Access Compliance Report

Public Rights-of-Way

(Pedestrian Signals)

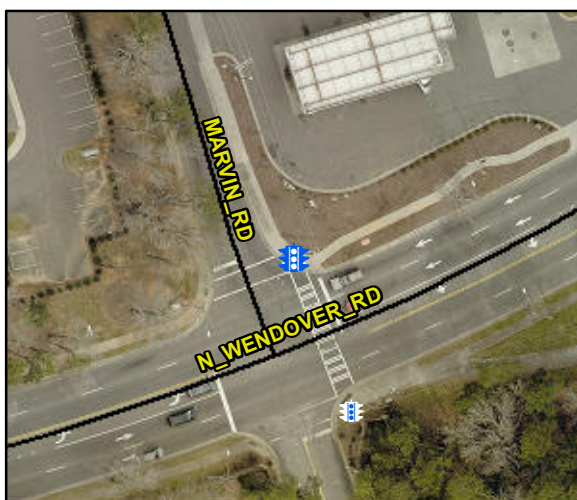
PROW/ADA: R209.1, TMUTCD 4e.08, R404.2, R404.3, R404.7.1, R404.7.2, R406

N/A	B 1 FWD Approach Width (in)	N/A	N/A	B 2 FWD Approach Width (in)	N/A
N/A	B 1 FWD Approach Obstruction?	N/A	N/A	B 2 FWD Approach Obstruction?	N/A
N/A	B 1 FWD Approach Obstruction Dist (in)	N/A	N/A	B 2 FWD Approach ObstructionDist (in)	N/A
No	B 1 PARA Approach?	No	N/A	B 2 PARA Approach?	N/A
N/A	B 1 PARA Approach Constrained?	N/A	N/A	B 2 PARA Approach Constrained?	N/A
N/A	B 1 PARA Approach Reach (in)	N/A	N/A	B 2 PARA Approach Reach (in)	N/A
N/A	B 1 PARA Approach Width (in)	N/A	N/A	B 2 PARA Approach Width (in)	N/A
N/A	B 1 PARA Approach Obstruction?	N/A	N/A	B 2 PARA Approach Obstruction?	N/A
N/A	B 1 PARA Approach Obstruction Dist (in)	N/A	N/A	B 2 PARA Approach ObstructionDist (in)	N/A
No	B 1 Clear Floor Space Slope (%)	5.4	N/A	B 2 Clear Floor Space Slope (%)	N/A
Yes	B 1 Clear Floor Space XSlope (%)	1.9	N/A	B 2 Clear Floor Space XSlope (%)	N/A
N/A	B 1 PAR Slope (%)	5.0	N/A	B 2 PAR Slope (%)	N/A
No	B 1 Height (in)	54.0	N/A	B 2 Height (in)	N/A

Yes	B 1 Clear Xing Direction?	ClearlyMarked	N/A	B 2 Clear Xing Direction?	N/A
	B 1 Crossing Direction	To SE		B 2 Crossing Direction	N/A
Yes	B 1 DistanceTo XWalk (in)	0.0	N/A	B 2 DistanceTo XWalk (in)	N/A
No	B 1 DistanceTo Curb (in)	80.0	N/A	B 2 DistanceTo Curb (in)	N/A
Yes	B 1 Diameter (in)	2.0	N/A	B 2 Diameter (in)	N/A

Possible Solutions: Replace Signal Push Button With APS Button on New Post.
